# UNITED STATES PATENT AND TRADEMARK OFFICE

10/552,730

<b>Office Action Summary</b>	<b>Application No.</b> 10/552,730	<b>Applicant(s)</b> NALESSO, FEDERICO	
	<b>Examiner</b> DAVID C. MELLON	<b>Art Unit</b> 1797

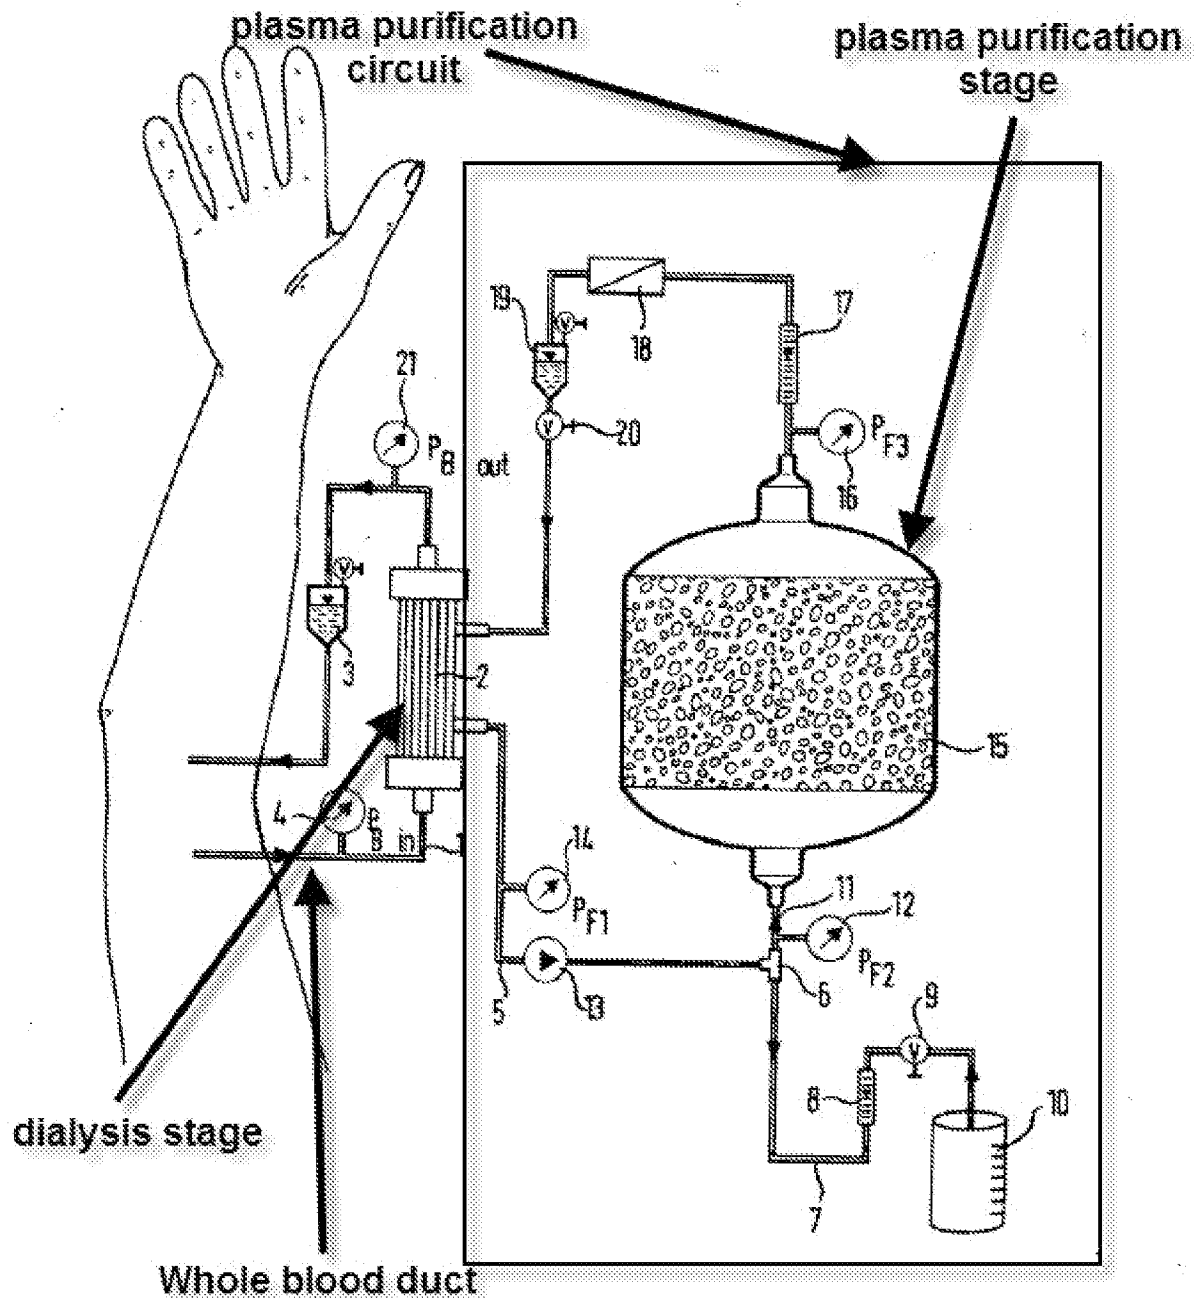
Regarding claim 14, Shettigar discloses an apparatus for the purification of blood (Abstract) in figure 1 and annotated figure above, comprising:

- A duct for the flow of whole blood (1 - conduction system)
- A stage for filtering plasma from the whole blood arranged along said duct (filter 15 for instance)
- A plasma purification circuit and connected with the plasma filtering stage (see annotated figure above)
- A stage for whole blood dialysis by means of plasma purified in said circuit, said stage for whole blood dialysis comprising a selectively permeable interface for separating at least part of the whole blood stream of said duct from a countercurrent stream of plasma purified in said circuit (2, see also P4/L1-40).

Regarding claim 16, Shettigar further discloses the plasma purification stage is connected to the dialyzing stage of the blood and connected downstream of the dialyzer stage (see figure and functional relationships between 15, 2, and the attaching ductwork).

Regarding claims 17 and 18, Shettigar further discloses a device for removing water-soluble and dialyzable toxic molecules that uses membrane-based adsorptive processes (15 - P4/L83-105 - carbon cartridges are membrane filters).

Regarding claims 20 and 21, Shettigar further discloses the unit (15) has a carbon adsorptive cartridge (P4/L83-105 - cartridge would be equivalent to column).
